Certificate of Appropriateness

Property 2525 N. SHERMAN BL. Sherman Boulevard Historic District Washington High School
Description of work MPS proposes to replace windows at Washington High School and to replace all of the existing doors, historic and non-historic. The former main entrance at Sherman Boulevard will be returned to a close approximation of its original appearance.
Date issued 12:00:00 AM PTS ID 100937 COA

Comparison between existing wood window profiles and metal replacement windows.

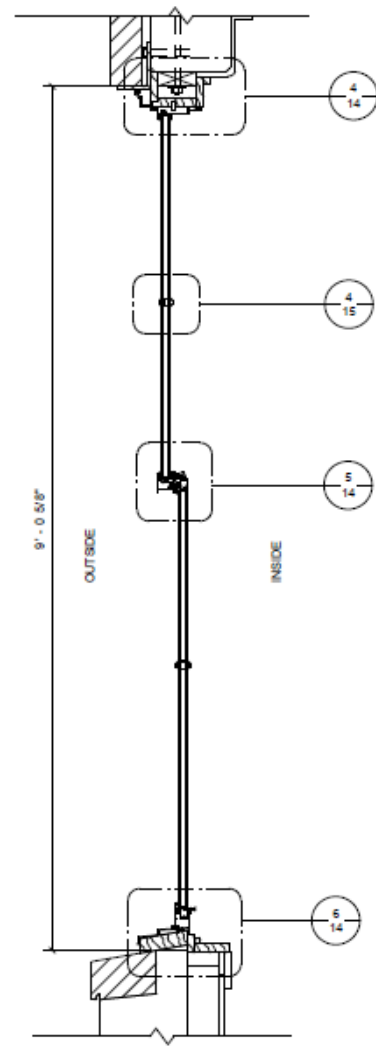
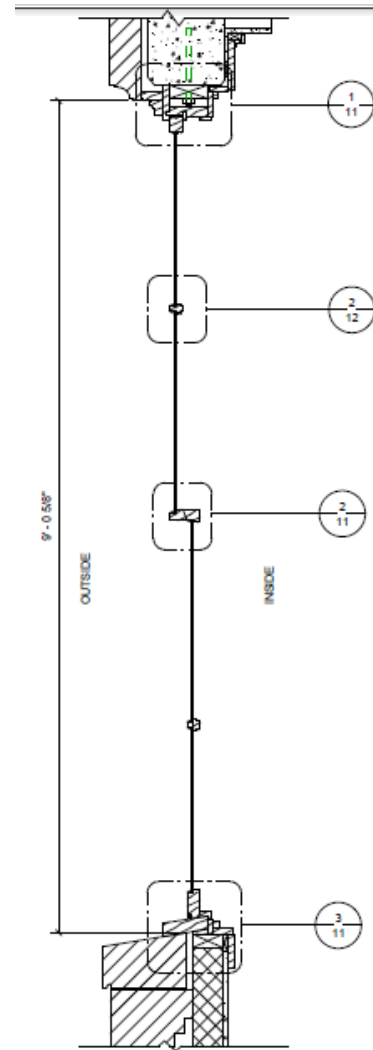
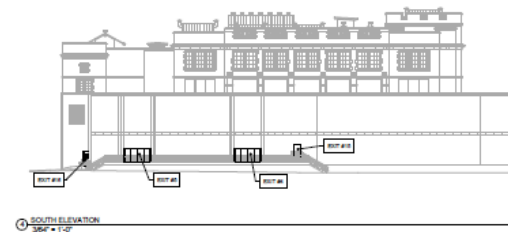
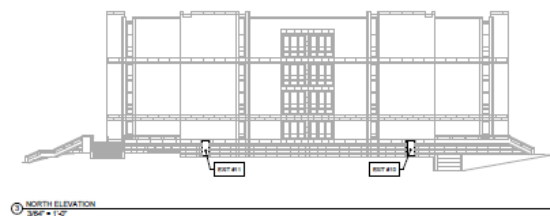
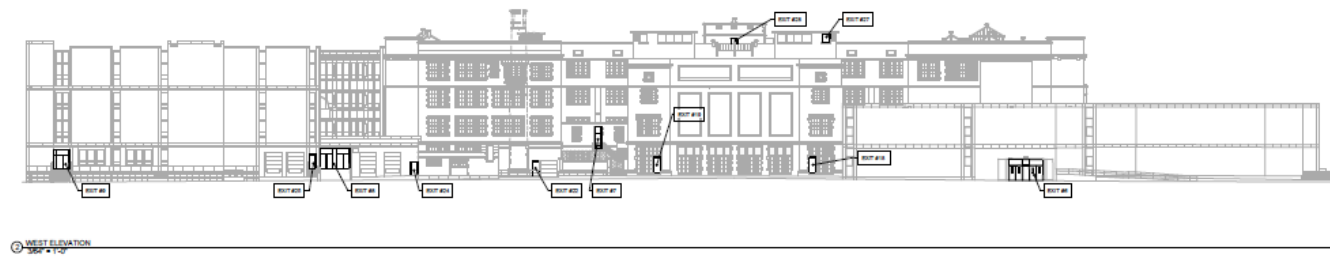
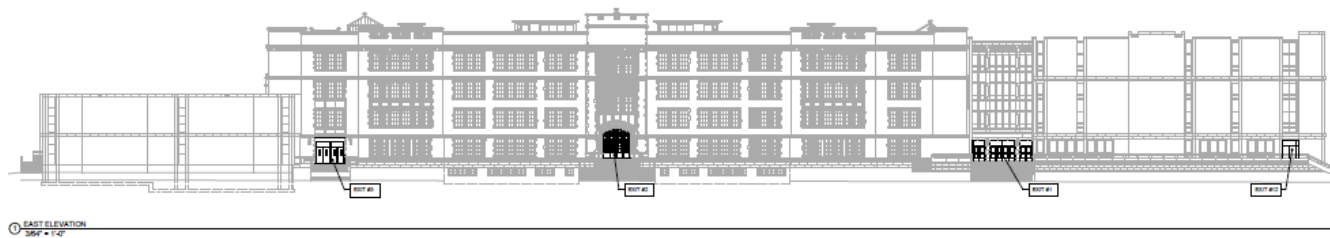
This is a close up of an original sash. New metal replacement must match this muntin profile, as well as dimensions of rails and stiles.

The new replacement windows must match exterior muntin profiles as well.

Rear wood windows fronting on 44th Street will be replaced with new metal single hung windows. The windows will be double paned, have fixed muntins on both the interior and exterior of the sash and the spacers will be black. The new windows will have simulated divided lites to match the existing muntin pattern and the muntin profiles will match the existing historic windows. The laminated and tempered glass will be clear. THIS APPROVAL FOR METAL WINDOWS IS LIMITED TO THE CIRCUMSTANCES OF WASHINGTON HIGH SCHOOL. IT DOES NOT CONSTITUTE BLANKET APPROVAL OF METAL WINDOWS IN OTHER INSTALLATIONS.

KEY PLAN

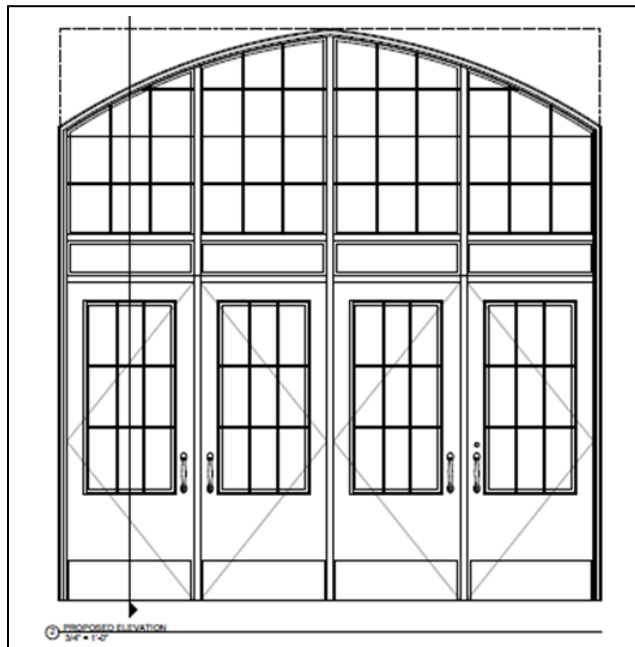
Locations where new doors will be installed.

The remainder of the doors around the school will be replaced with new fiberglass doors that will have a textured, sparkly appearance. The doors will fall into several main types as shown attached.

SpecLite 3® FRP

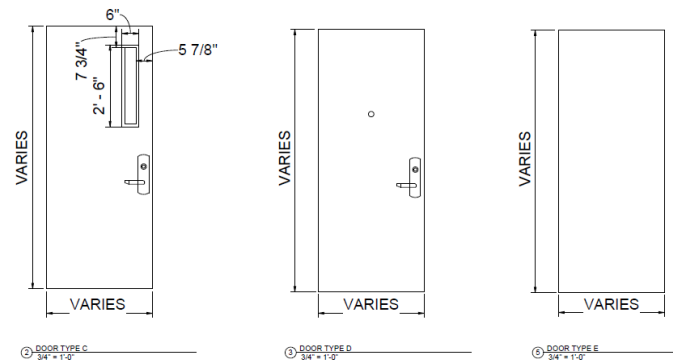
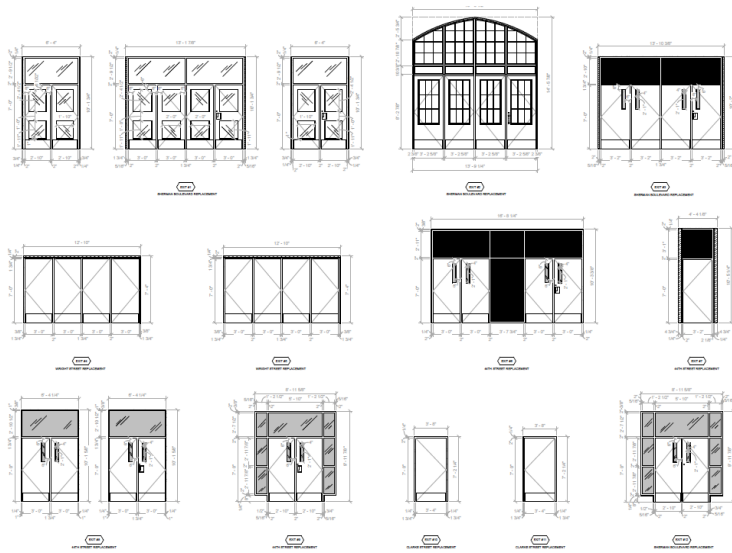
Replacement doors will be made of fiberglass with a textured, sparkly finish. The doors at the former main entrance will have a smooth finish.
